REPORT TO PLANNING COMMISSION

Hearing Date: June 11, 2012
File Number: 2012-7012

SUBJECT: **Steve Hoffman (Appellant) / 162 N Wolfe LLC (Applicant/ Owner)**: Application for a 0.36-acre site located at **162 North Wolfe Road** in an M-S Zoning District (APN: 205-43-027):

Motion **2012-7012 –** Appeal of a decision by the Director of Community Development approving a Miscellaneous Plan Permit for parking lot restriping and minor landscaping modifications.

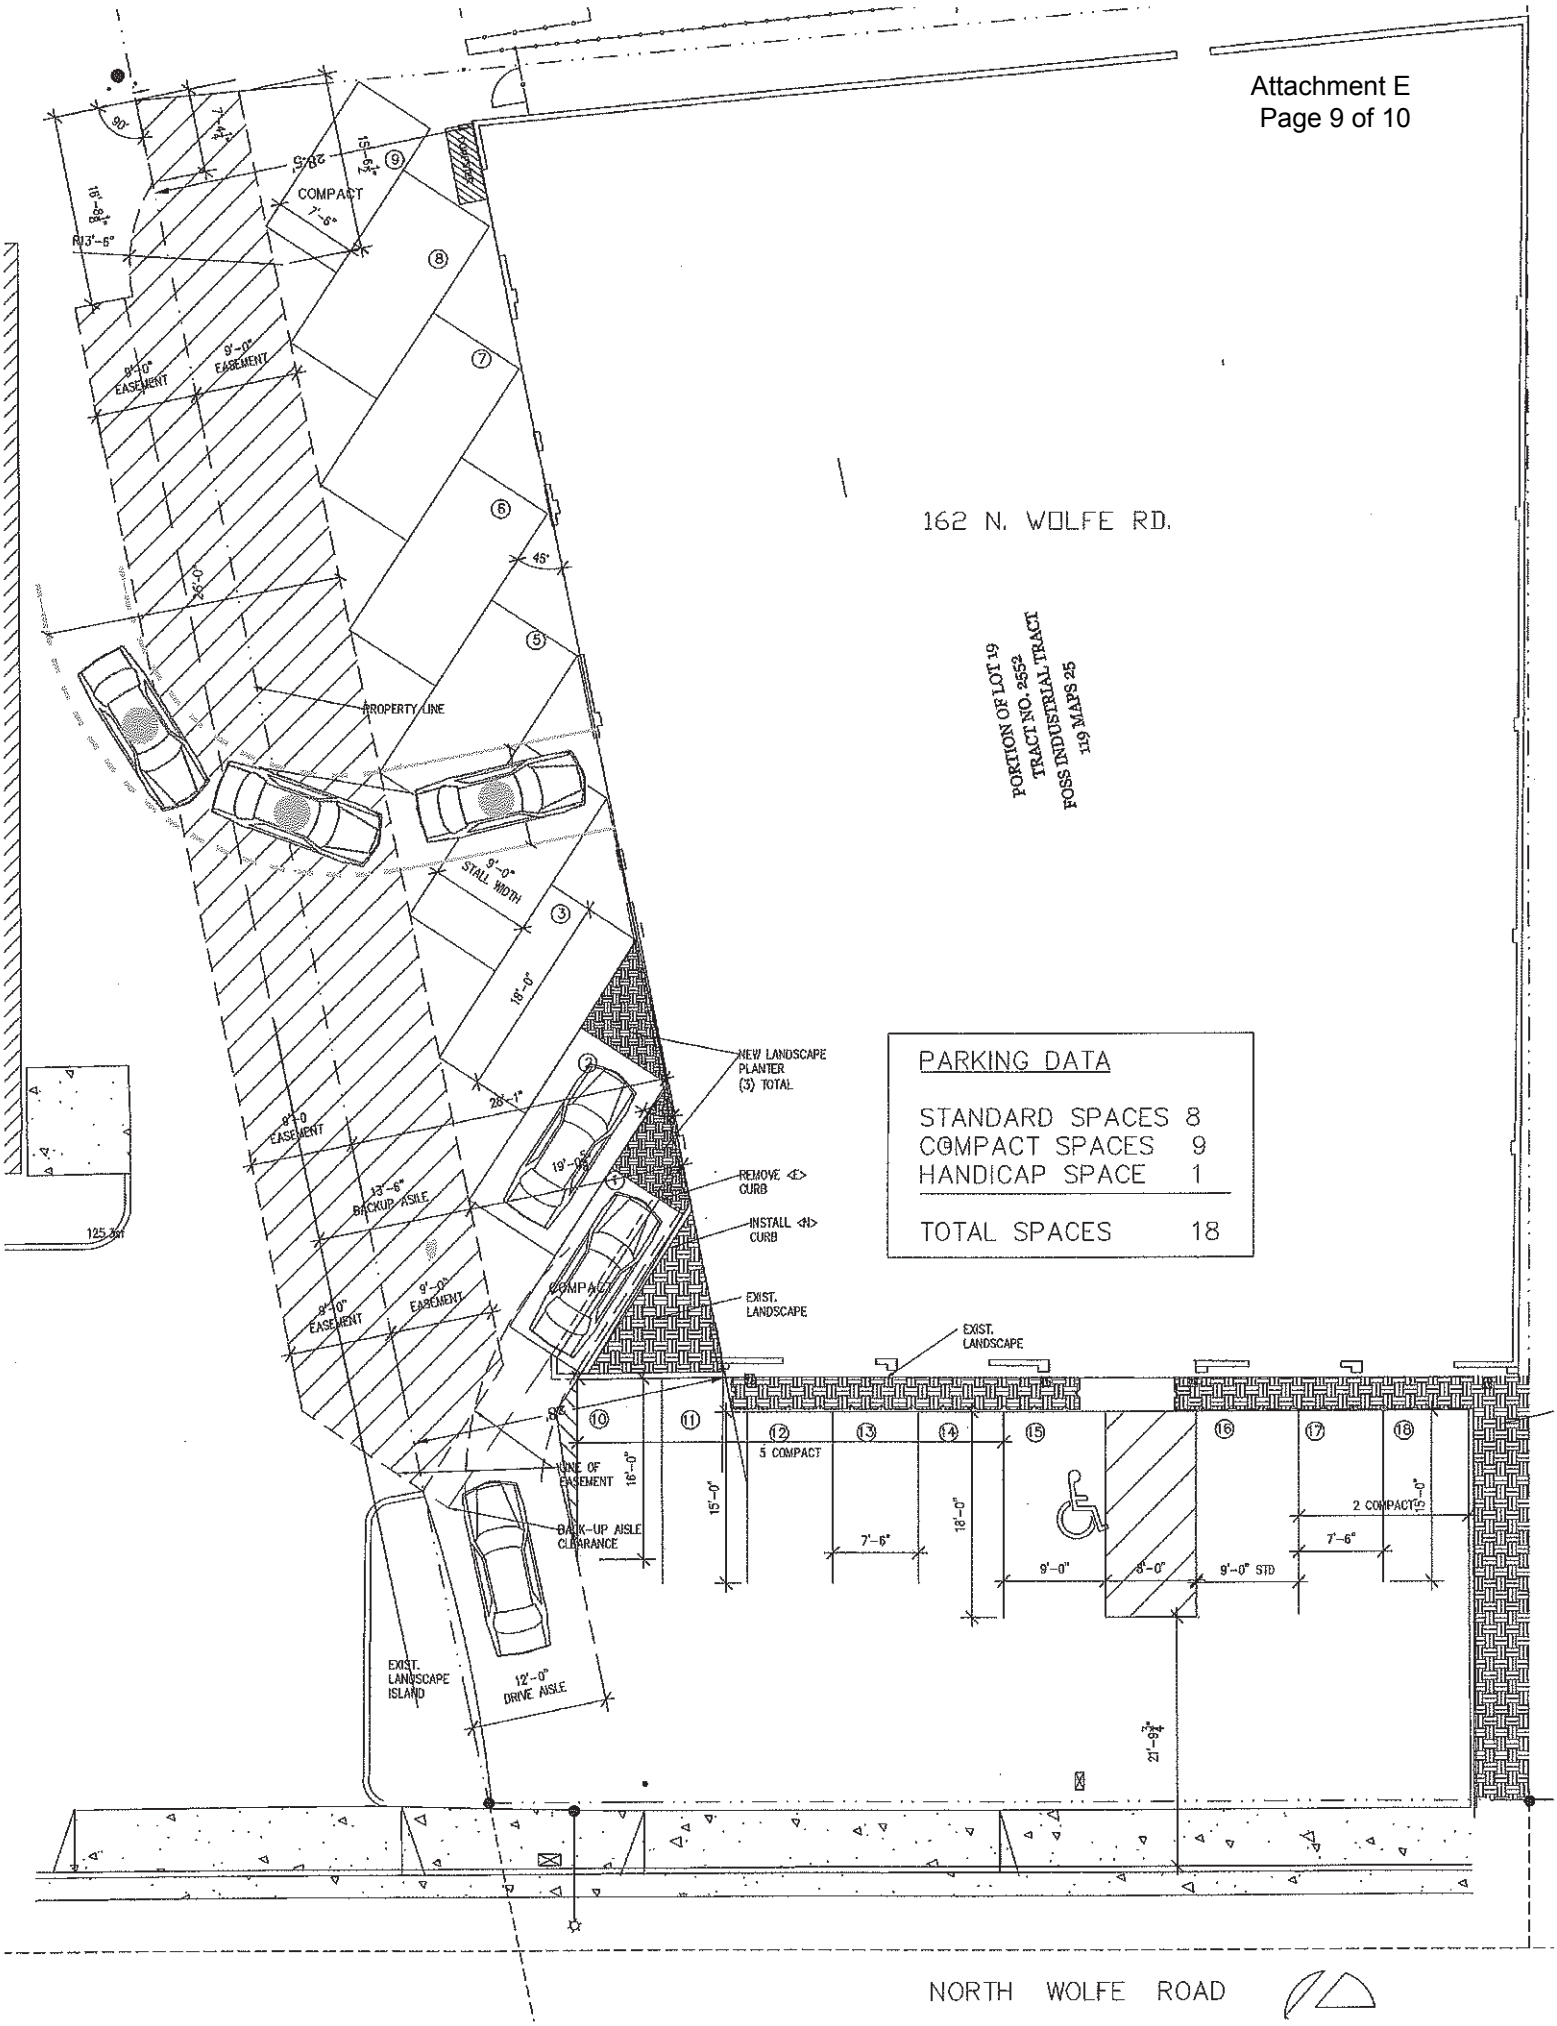
Passage arc is based on my understanding of the code. Steve Hoffman

Staff response: The appellant provides six diagrams depicting a vehicle turning into the angled parking spaces along the north side of the building. These diagrams appear to indicate that a vehicle cannot enter the angled spaces without driving over an existing landscaping area or crossing outside the easement area. The turning radius shown in these diagrams does not match accepted turning templates used by the City's Transportation and Traffic Division. The first four diagrams suggest a vehicle must swing widely to the left before turning into the angled parking spaces. Transportation and Traffic staff has reviewed the diagrams and confirmed the wide arc shown on these plans would not be necessary for a passenger car or truck. The required drive aisle width of 12 feet would be sufficient to allow vehicles to enter the spaces, and the required back-up distance of 13.5 feet would be sufficient to allow vehicles to reverse out of the spaces. Additional maneuvering area should not be needed. The fifth and sixth diagrams depict a vehicle entering the angled parking spaces from the east. As noted in #2 above, vehicles entering from the east could back into the parking spaces. In addition, implementation of the Parking Management Plan will address concerns about these vehicular movements.

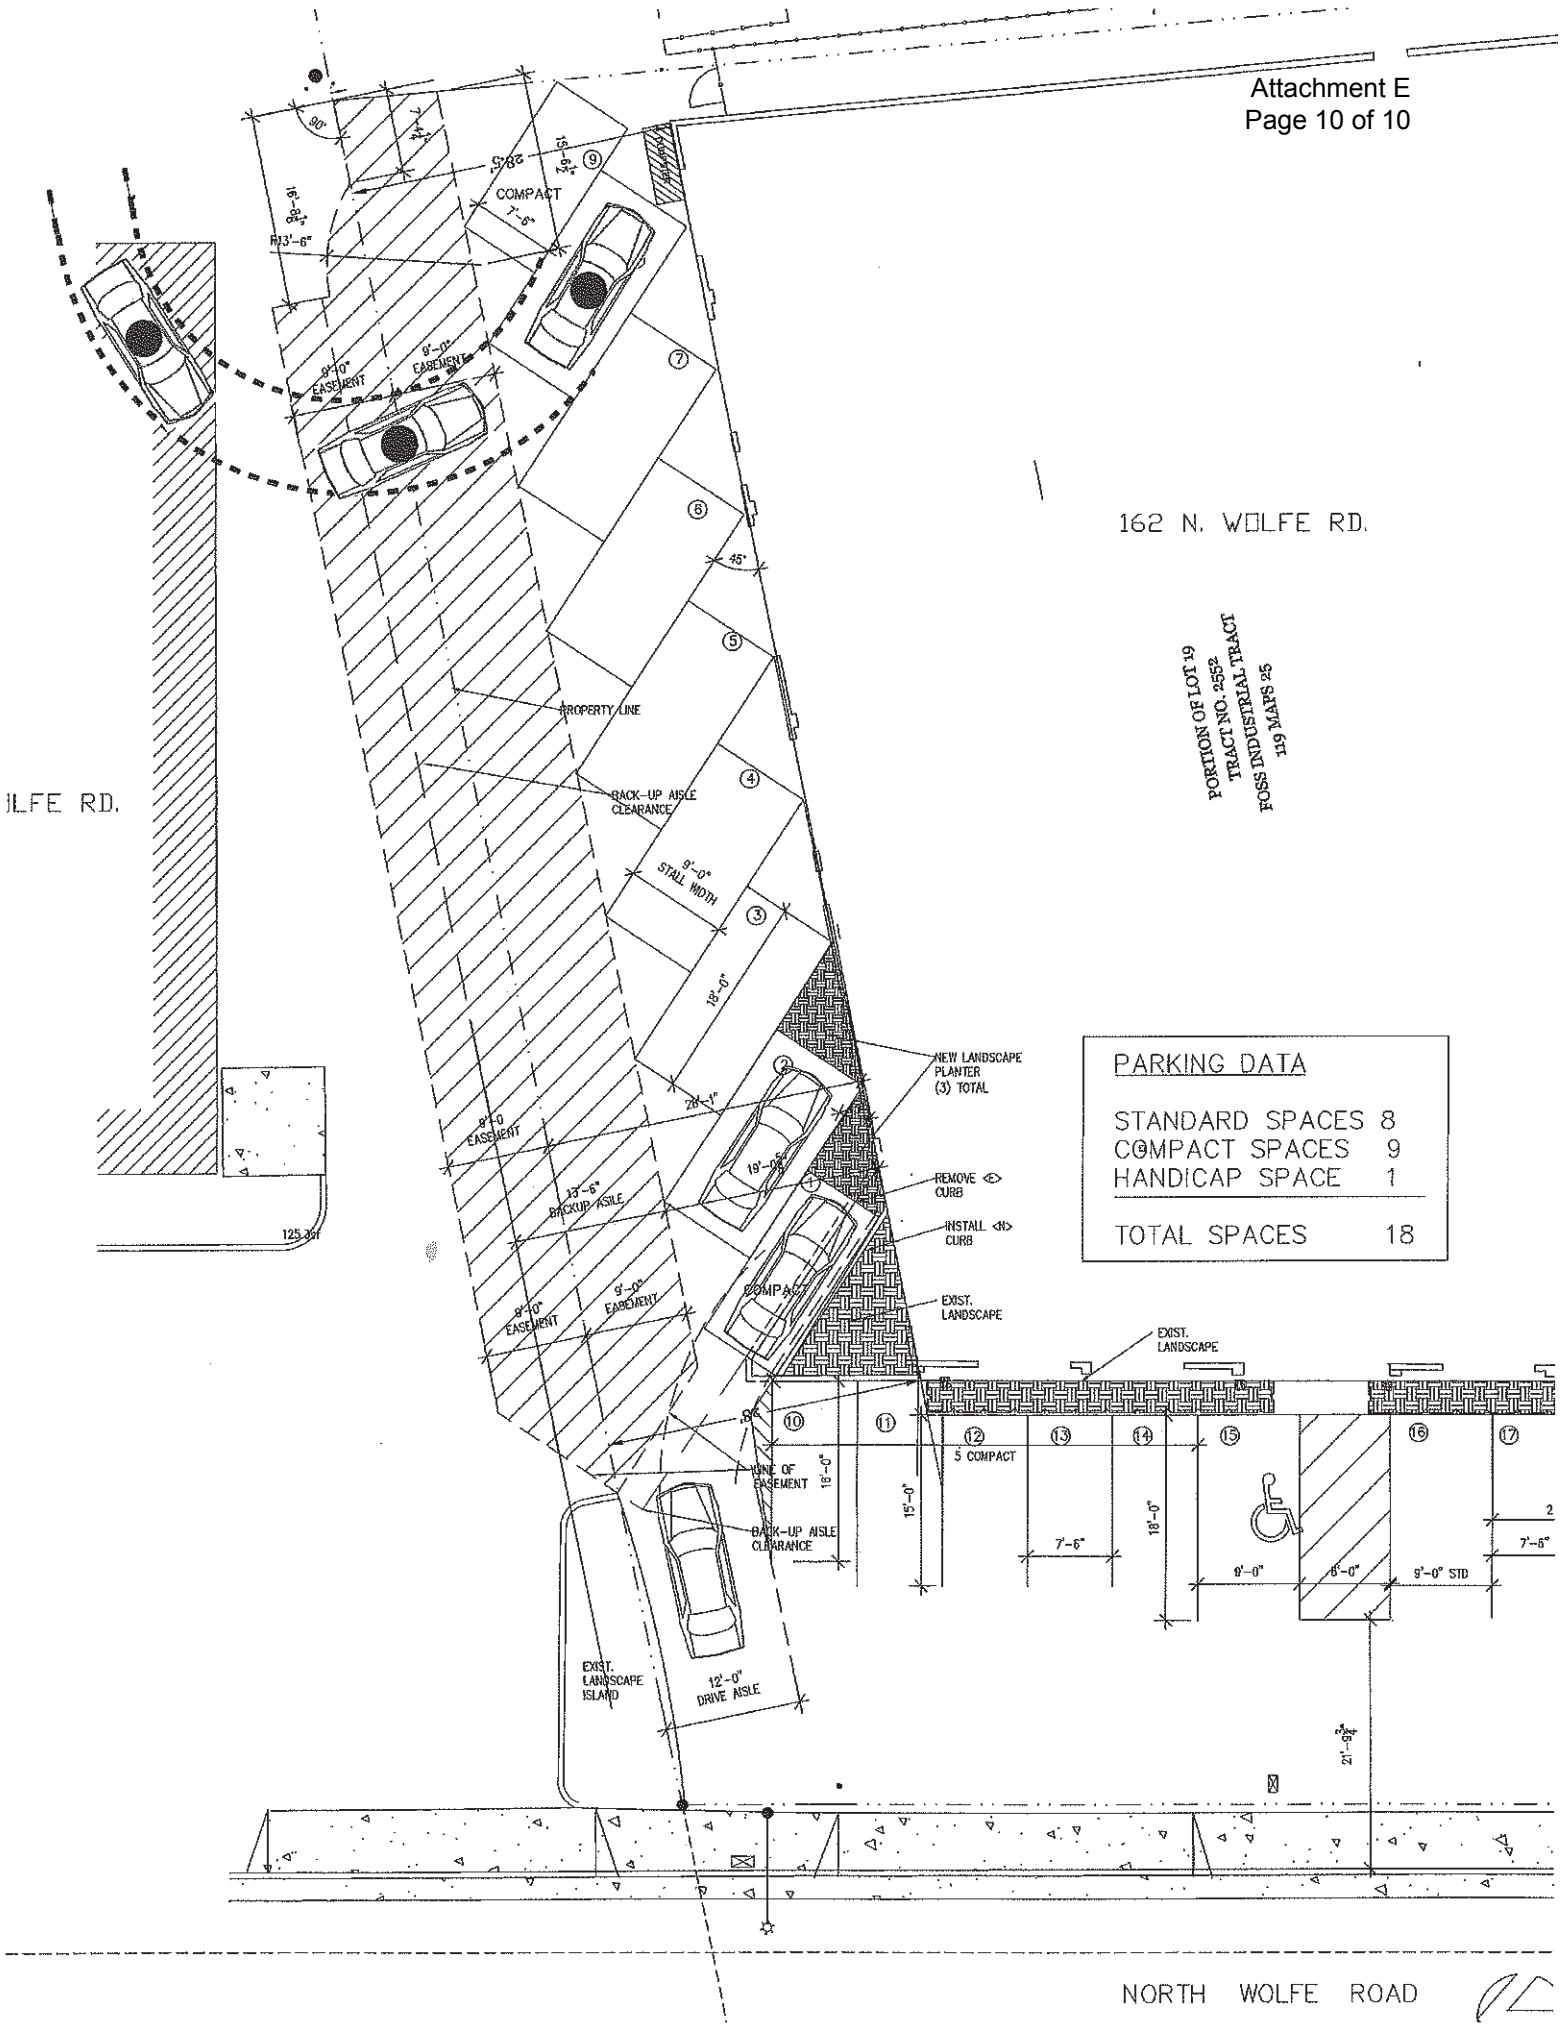
Passage arc is based off my understading of the code. Steve Hoffman.
